ZONING BOARD OF ADJUSTMENT, PANEL C
MONDAY, APRIL 15, 2019
AGENDA

BRIEFING	5ES 1500 MARILLA STREET DALLAS CITY HALL	11:00 A.M.
PUBLIC HEARING	COUNCIL CHAMBERS 1500 MARILLA STREET DALLAS CITY HALL	1:00 P.M.

PLANTING PLAN

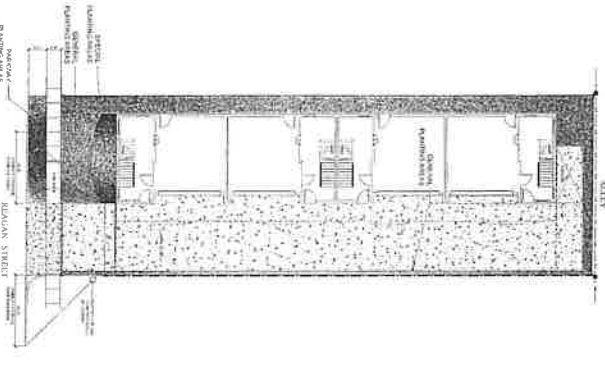
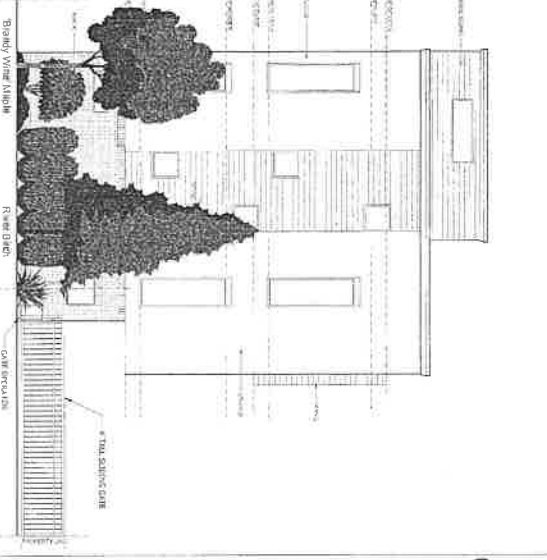
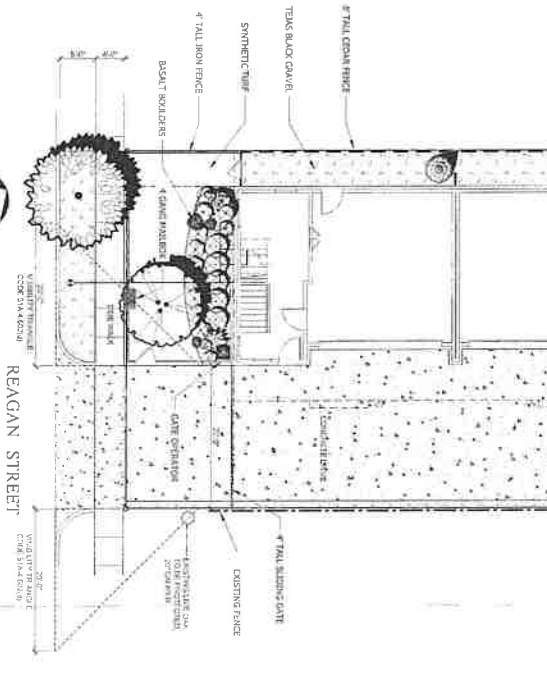
- The Chief Arborist's memo states the following with regard to "provision":
 - The proposed alternate landscape plan demonstrates compliance with all landscape requirements for area for landscape site area, general planting area, special planting area, and for sidewalks, tree planting zone and screening. The exception is for the use of a synthetic turf in the parkway.

- The landscape site area (LSA) differs from the general planting area, special planting area, and parkway planting area, in that there is no minimum planting requirements that are outside the general, special, and parkway planting areas. The ordinance specifies the general, special, and parkway planting areas must have 'living trees, shrubs, vines, flowers, or ground cover vegetation.' There are no minimum soil depth requirements for portions of the landscape site area outside of the general and special planting areas.

- Synthetic turf has multiple manufacturers and methods of installation and operation. The materials and subgrade conditions should allow for permeability through the surface membrane to the soils below to be considered permeable. No pavement (with exception for pedestrians) is permitted in the landscape site area. All landscaping must have an automatic irrigation system. These factors suggest the LSA should be a permeable landscaped area, but the PD 193 ordinance does not give specific criteria for anything but the GPA, SPA, and Parkway planting area.

- The Chief Arborist's memo states the following with regard to "deficiencies":
 - The parkway planting area with synthetic turf would not conform to the standard for living plant materials, including groundcovers, in parkway locations. The landscape site area should also be living plant materials, though the PD 193 ordinance does not give clear direction.

1. Compliance with the submitted revised alternate landscape plan is required.
2. If the director should determine that the synthetic turf should not be authorized or maintained on the public right-of-way, the applicant must restore the parkway landscape area to a living natural ground cover plant.

- The City of Dallas Chief Arborist recommends conditional approval of the request because the special exception would not compromise the spirit and intent of the PD 193 regulations. If the director should determine that the synthetic turf should not be authorized or maintained on the public right-of-way, the applicant must restore the parkway landscape area to a living natural ground cover plant.

PERMIT ALTERNATIVE COMPLIANCE PLAN

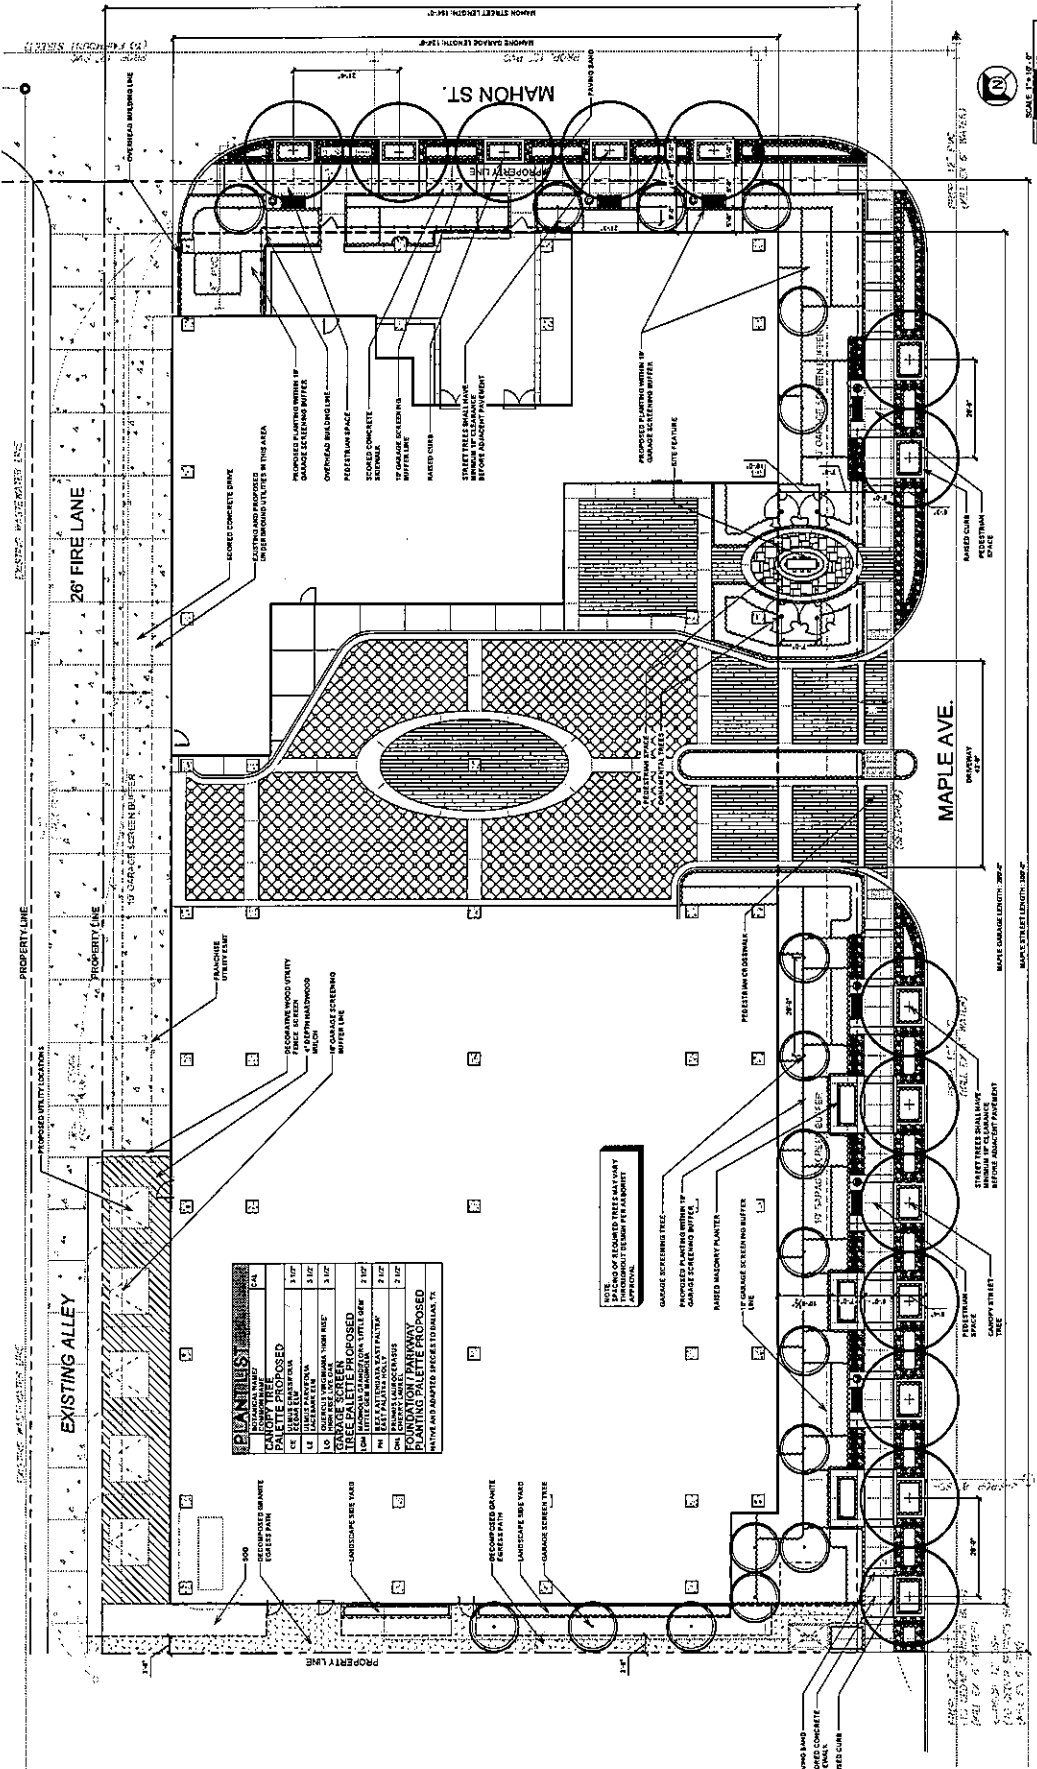
- The Chief Arborist's memo states the following with regard to "request":
 - The applicant is requesting a special exception to the landscaping regulations of PD 193, Part 1 for HC districts. The alternative landscape plan is for new construction of a multifamily development without the required garage screening and landscaping buffer.

- The Chief Arborist's memo states the following with regard to "provision":
 - The proposed alternative landscape plan complies with PD 193(HC) regulations for street trees, sidewalks, and screening of off-street parking. Other standards for landscape site area and general or special plantings are not applicable.

- The Chief Arborist's memo states the following with regard to "deficiencies":
 - The plan does not provide for the required garage screening and landscaping as described in Section 51P-193.126 (b) (3) (D). Aboveground parking structures are required to have a 10-foot landscaping buffer on any side facing a public right-of-way, residential district, residential subdistrict, or residential use, and have a minimum of one tree for every 25 feet of frontage and evergreen shrubs planted three feet on center to create a solid appearance.

- Compliance with the submitted revised alternate landscape plan is required.
